CITY OF ALBUQUERQUE

**RE: Main Event, Pan American Freeway and Vassar Drive
Grading Plan and Drainage Plan
Engineer's Stamp Date 5-07-2015 (File: G16-D149)**

DRAINAGE AND TRANSPORTATION INFORMATION SHEET

**RE: MAIN EVENT,
PAN AMERICAN FREEWAY AND VASSAR DRIVE
GRADING PLAN AND DRAINAGE PLAN
ENGINEER'S STAMP DATE 3-27-2015 (FILE:G-D149)**

<p>ENGINEER'S SEAL</p> <p>RONALD R. BOHANNAN P.E. #7868</p>	MAIN EVENT		DRAWN BY
	PAN AM FREEWAY AND VASSAR AV.		BJF
	GRADING PLAN		DATE
	<p>TIERRA WEST, LLC 5571 MIDWAY PARK PLACE NE ALBUQUERQUE, NM 87109 (505) 858-3100 www.tierrawestllc.com</p>		05/06/15
	SHEET #		2015015_GRB
JOB #		C5	
2015015

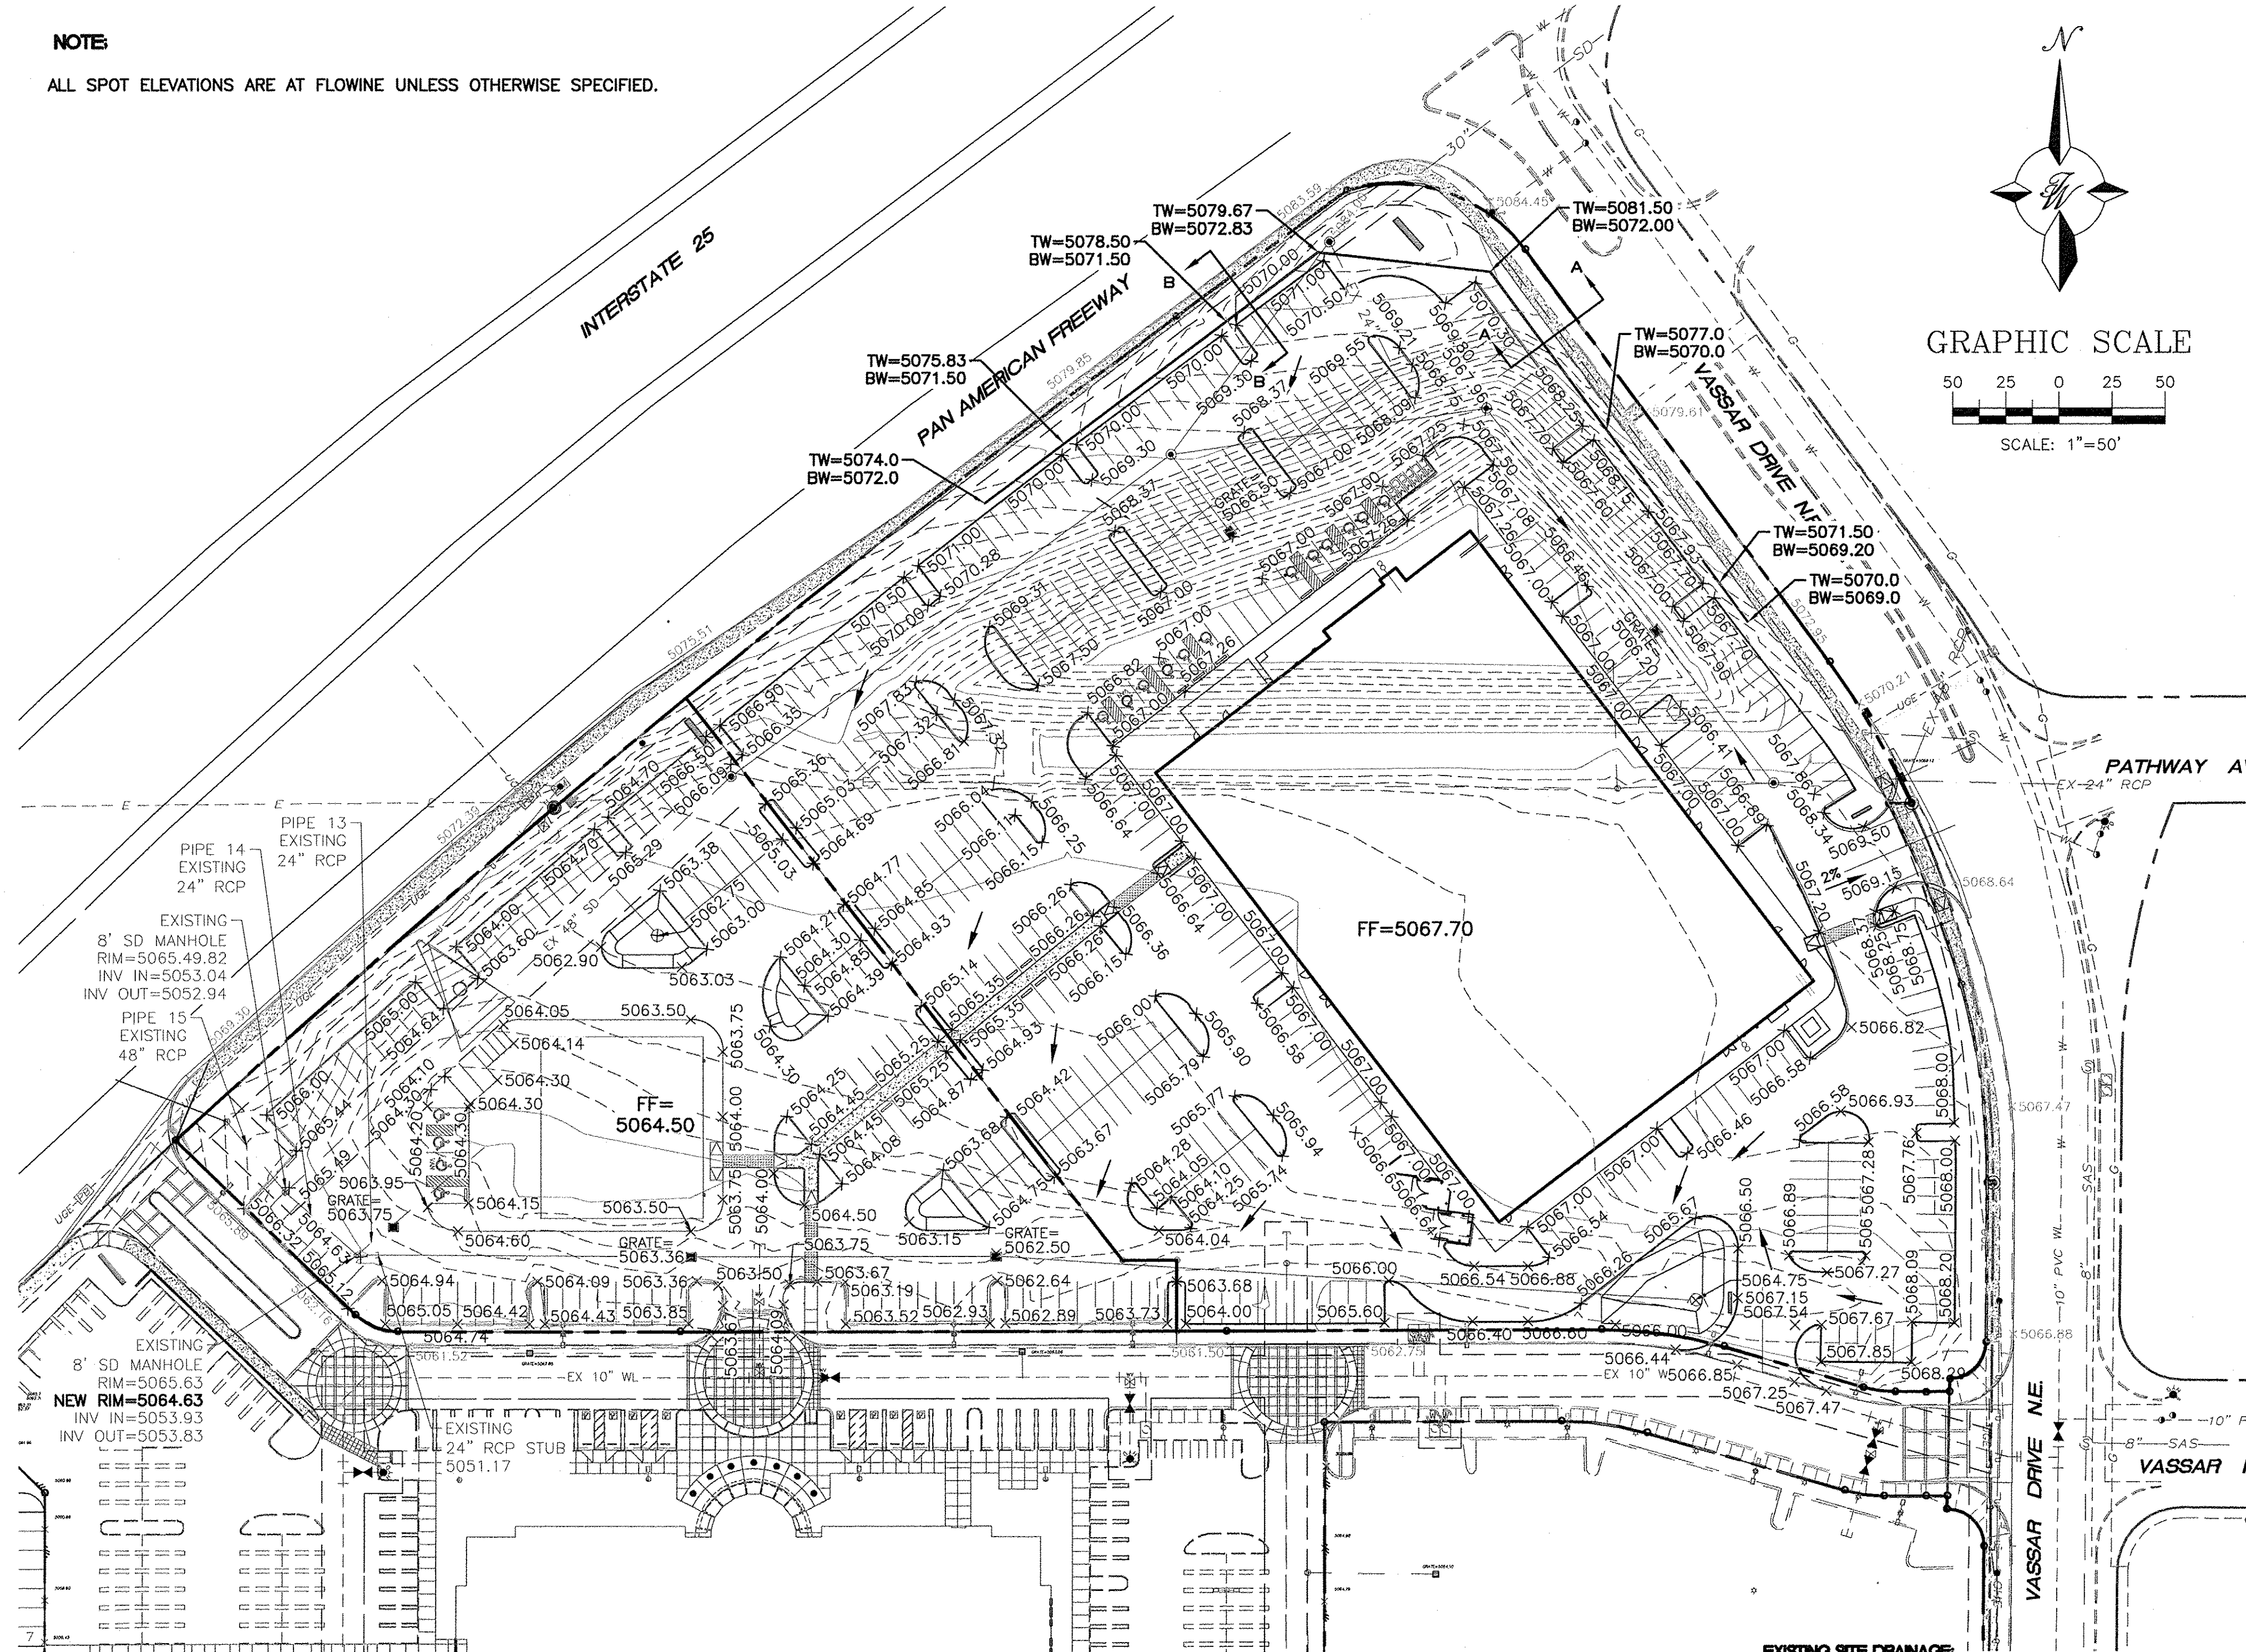
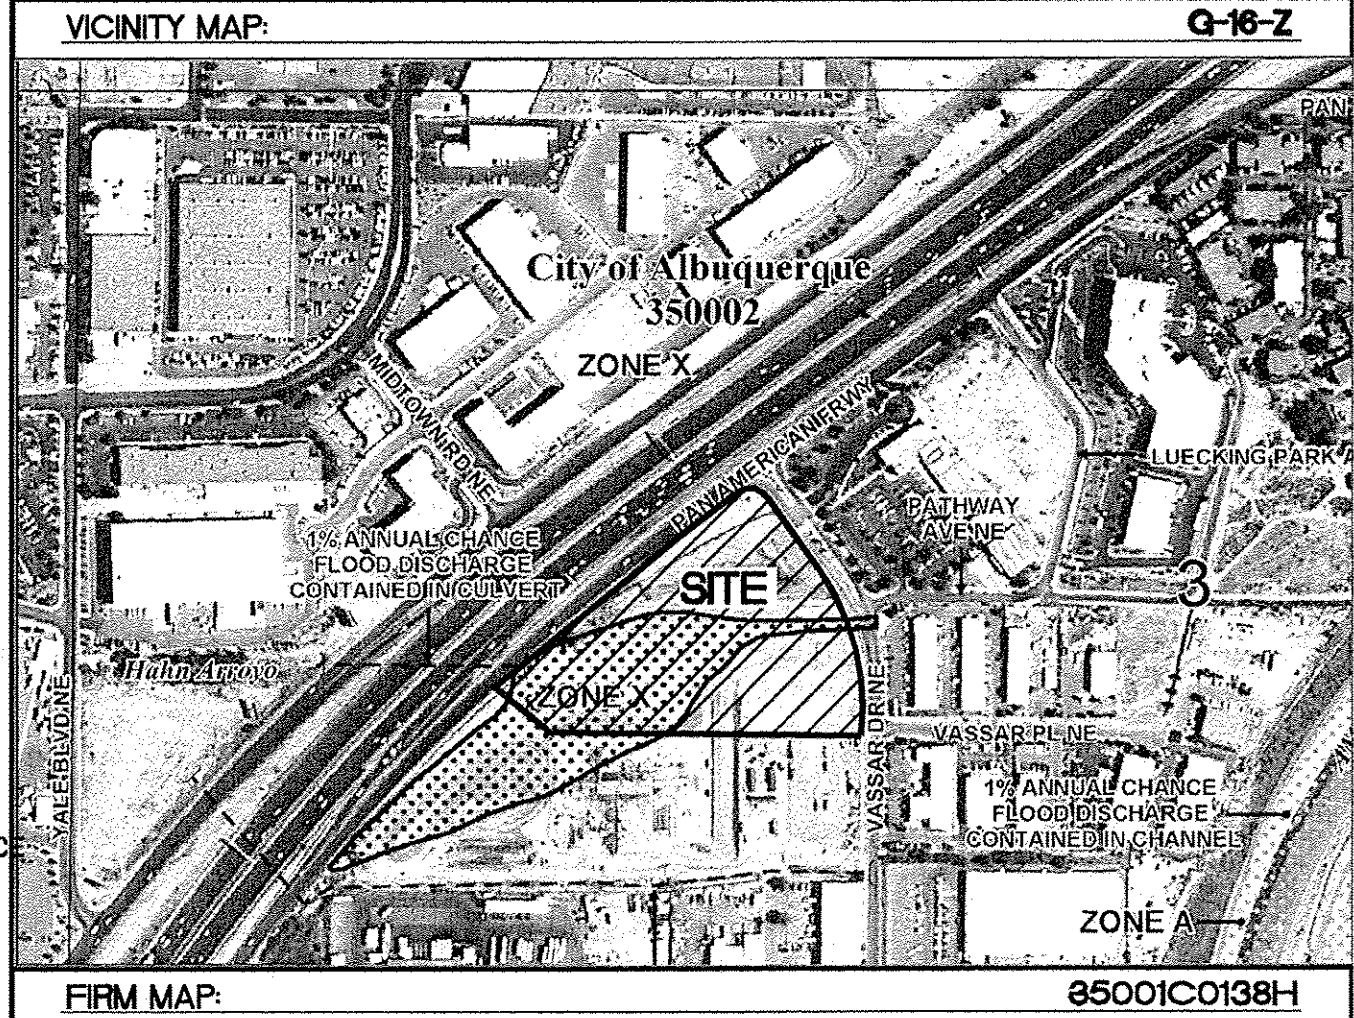
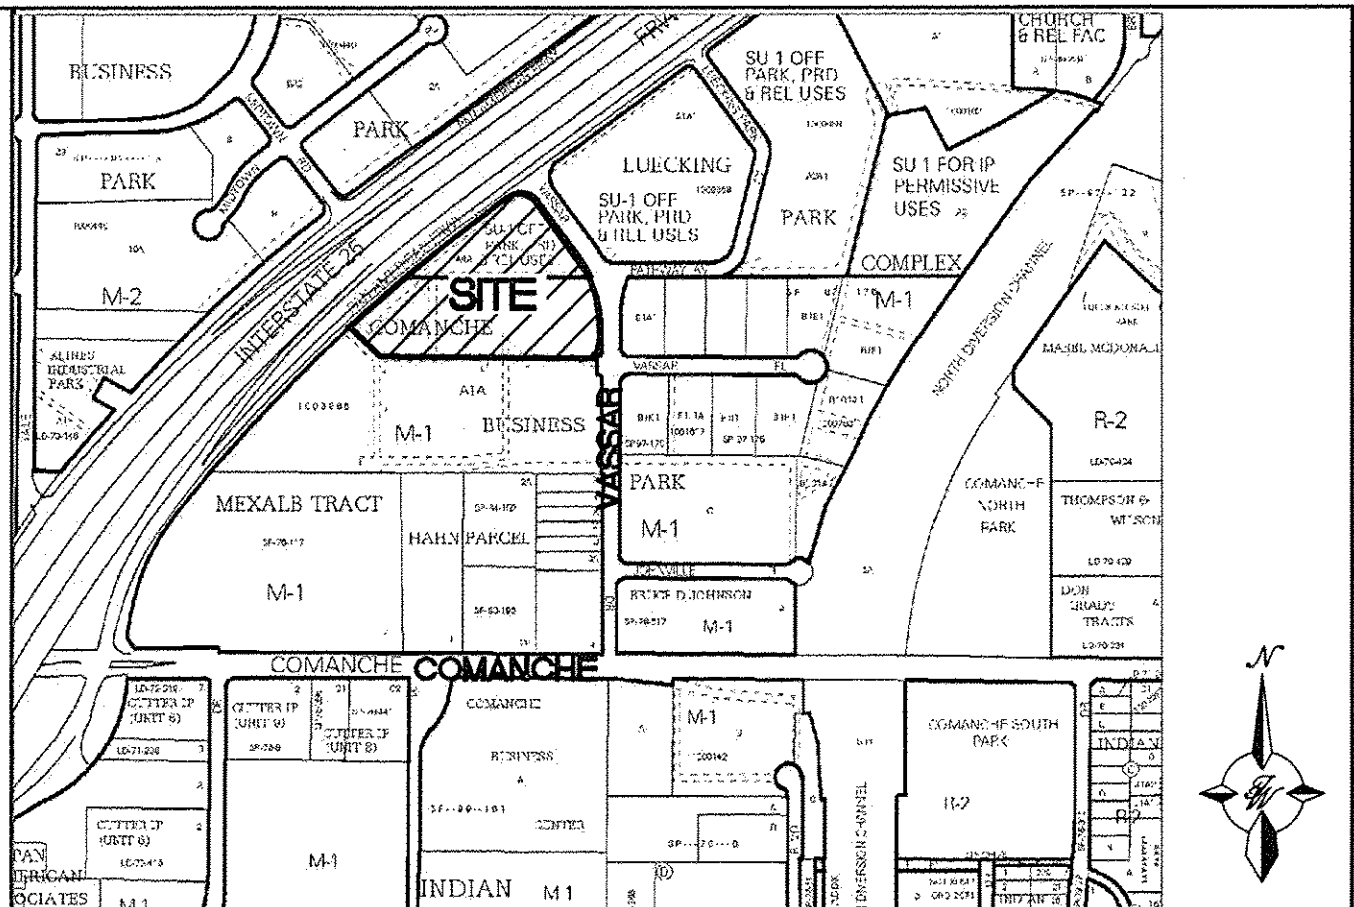
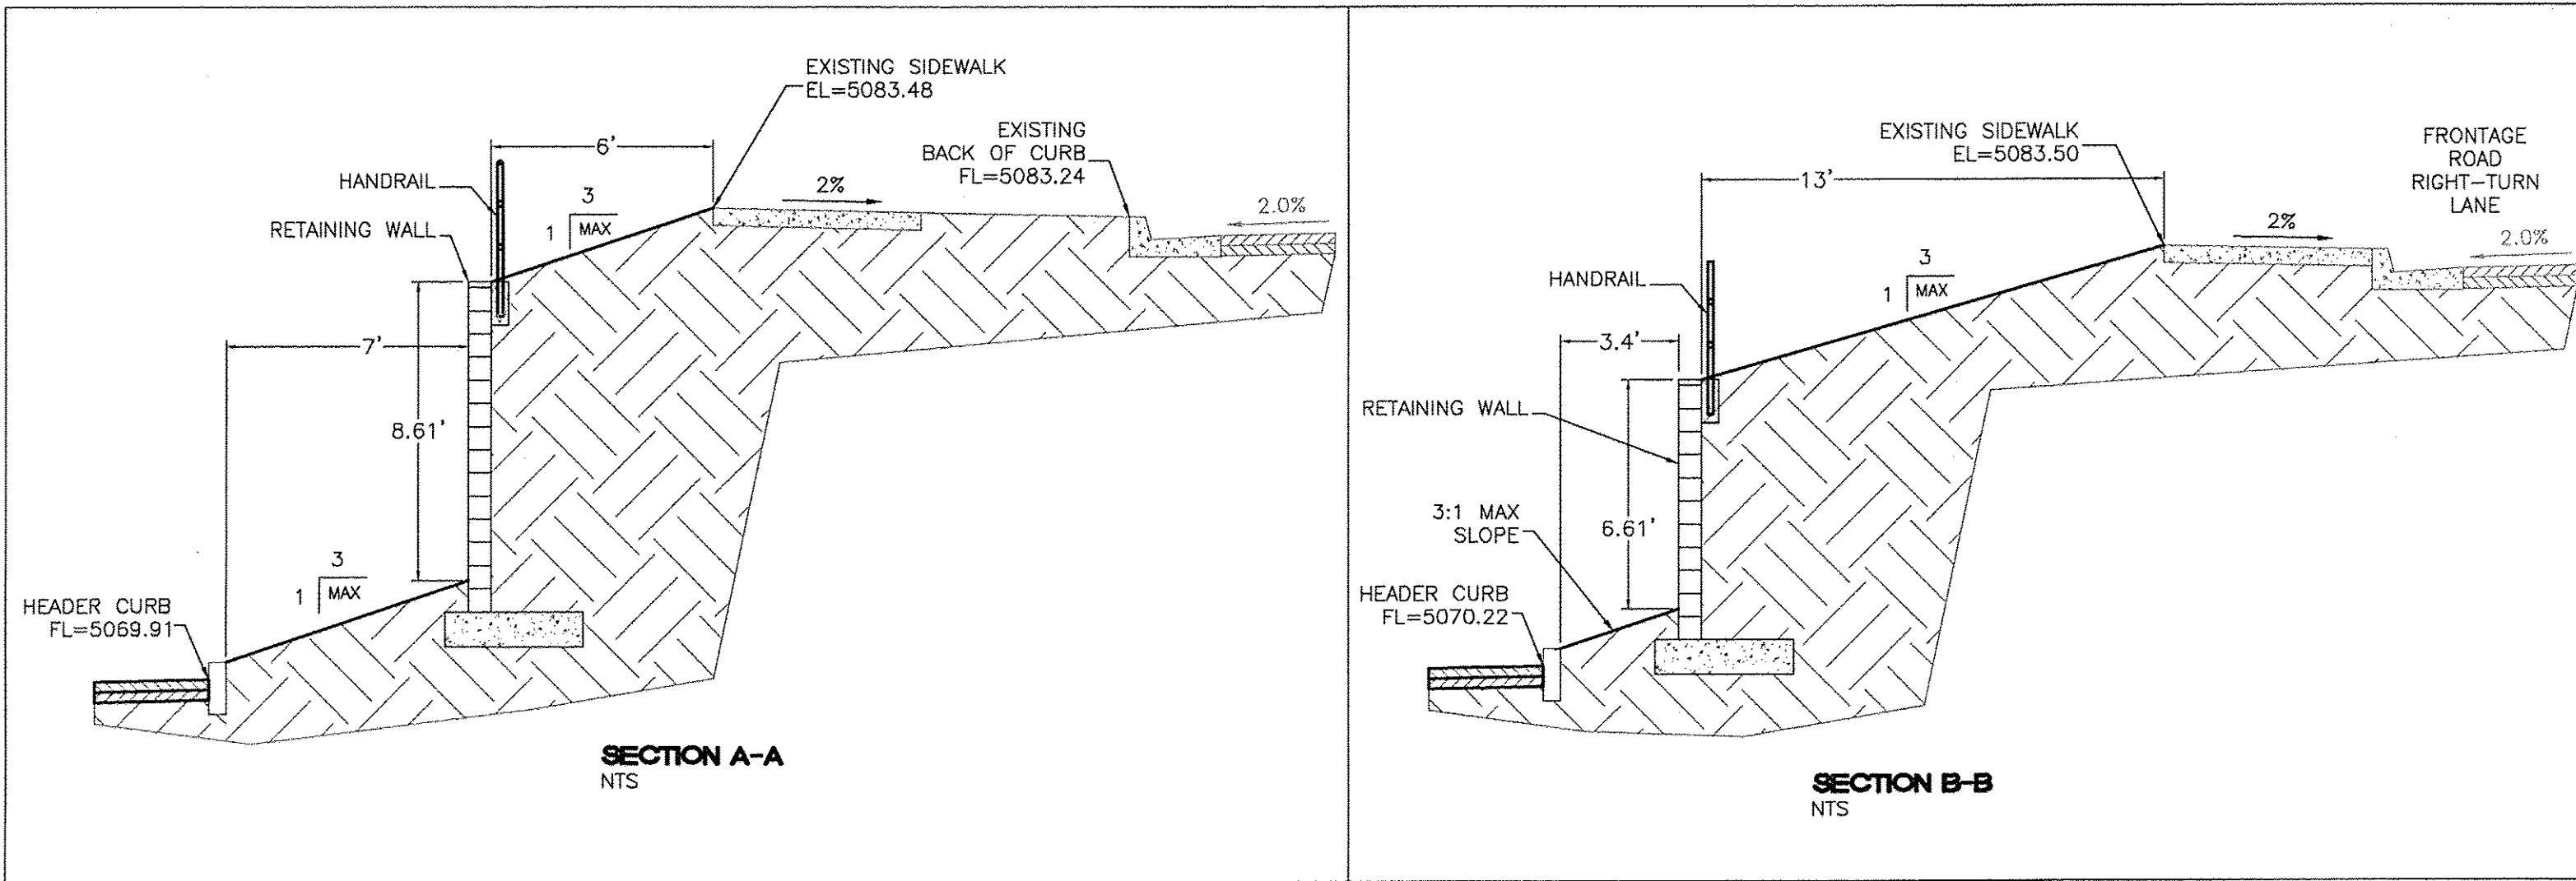
5. Check the middle entrance to the private drive south of the building with regard to grade elevations. A couple of new spot elevations are shown to be 3 feet off from existing spot elevations, creating a very steep drop. Include more existing spot elevations within the public and private roads surrounding the site. **There is no middle entrance. The existing entrance is being eliminated. A note was added to show that we are adding curb and gutter in this location to make it clearer.**

7. It looks like an approximate 3:1 slope is being crated between the Pan American Freeway and the retaining wall along the parking lot. Provide Section A-A symbol on the plan view. There is an elevation discrepancy where the top of wall elevation is 5079.67, and there is an existing 5084.0 spot elevation as well as a 5086.90 for new manhole rim elevation within very short distance from the wall. **Section A-A was already shown for the cross-section on Vassar Drive so Section B-B was added on Sheet C5. The manhole rim elevation was corrected.**

9. Specify elevations in parking lot to be at bottom of curb if this is the case. **A note was added to the Grading Plan stating that all spot elevations are at flow line unless otherwise specified.**

ALL SPOT ELEVATIONS ARE AT FLOWLINE UNLESS OTHERWISE SPECIFIED.
